BOONE COUNTY, MISSOURI Request for Bid #: 44-11DEC14 – Emergency Communications Center

ADDENDUM #6 - Issued December 18, 2014

A6-1

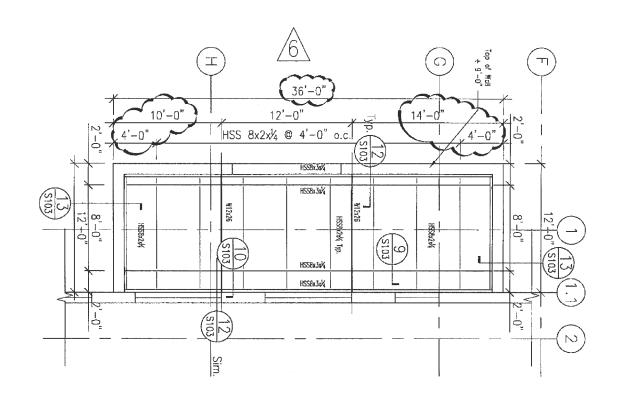
- 1. No drawing Coordination of precast suppliers and steel supplier is the responsibility of the General Contractor.
- 2. A6-1 7/S103 Dimensions of condenser enclosure changes.
- 3. A6-2 8/S103 Dimensions of condenser enclosure changes.
- 4. A6-3 S001 "Precast Concrete" Design requirements clarificatied
- A6-4 S001 "Design Criteria" Seismic system design category, system, and base shear changed. Overhang wind pressure clarified.

Condenser Enclosure Foundation Plan

Ref. 7/S103 | 1/8"=1'-0"

INTERIOR ELEVATIONS -MULTI-MEDIA CONTROL WORK CENTER #119

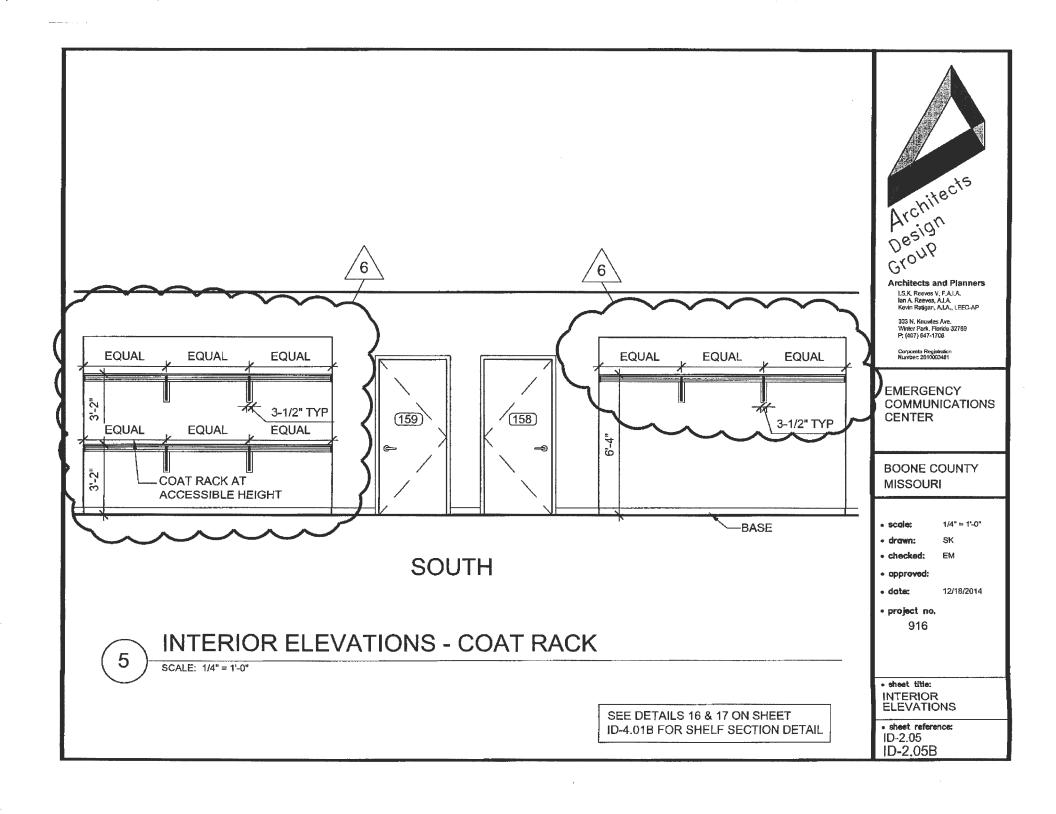
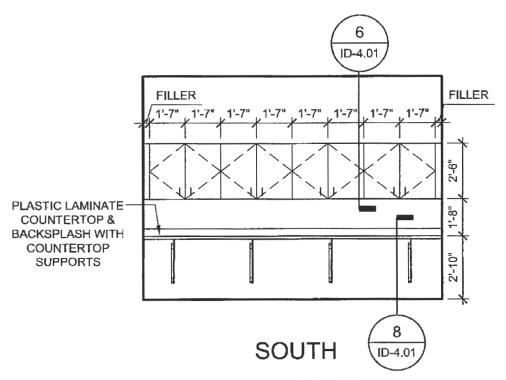
5. Plan on sheet A-1.03 seems to show casework in room 119 on the south wall. Is there any casework at this location? If so are there any details or elevation available?

- 1. ID-2.05
 - 1.1. ID 2.05B Changed the elevations of the Coat Racks.
- 2. ID-2.07
 - 2.1. ID 2.07C Added the elevations of the Casework at the Multi-Media Control Work Center 119...
- 3. ID-2.05
 - 3.1. ID 4.01B Added details for the Shelf and Rod for Coat racks at Coat Closet 103 and Corridor 150.
- Clarification: Interior Elevations: All Countertops denoted as "Solid Surface" on the drawings refer to Natural Quartz and Resin Composite Countertops as indicated in specification section 123600 Countertops.

RESPONSE: See attached drawings for details.

sheet reference: ID-4.01 ID-4.01B

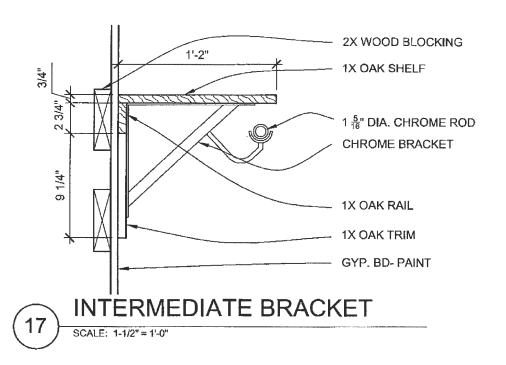
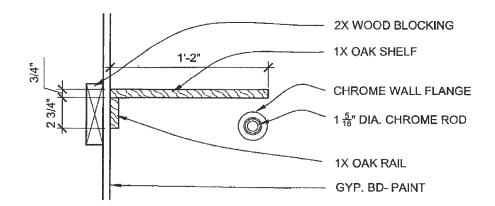
6. Is there a detail of the Coat Rack Corridor 150?

THESE DETAILS APPLY TO ALL COAT **CLOSETS INCLUDING CORRIDOR 150** & COAT CLOSET 103.

RESPONSE: See attached drawings for details.

2.07 HARDWARE

- A. Hardware: Comply with BHMA A156.9.
- B. Shelf and Rod Brackets: Knape & Vogt, 1198BP CHR 12 Extra-Duty Fixed Rod & Shelf Bracket, Chrome; www.knapeandvogt.com

- 1. One piece-Install full width of shelf.
- C. Round Closet Rod: Knape & Vogt, 770 5 CHR, 1-5/16" Extra Duty Chrome Rod; www.knapeandvogt.com.
- D. Wall Mount Flange Brackets for Rod Ends: Knape & Vogt, 764 CHR and 766 CHR Extra Duty wall mount flanges for rod ends. www.knapeandvogt.com.
